Product Change Notice (PCN)

PCN Number: PCN-0381029R-01

Product(s) Affected: *GF0668*

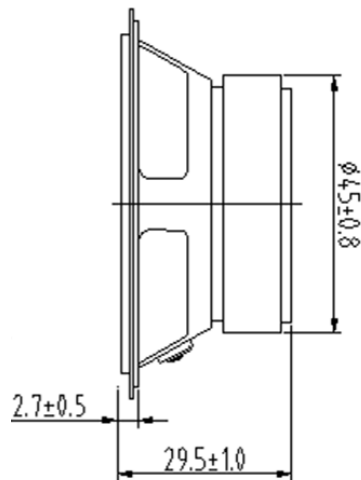
Description of Change: *SPL increased to 91dB, operating temperature range -20~60°C, brown gasket is now black, dimensional changes shown below:*
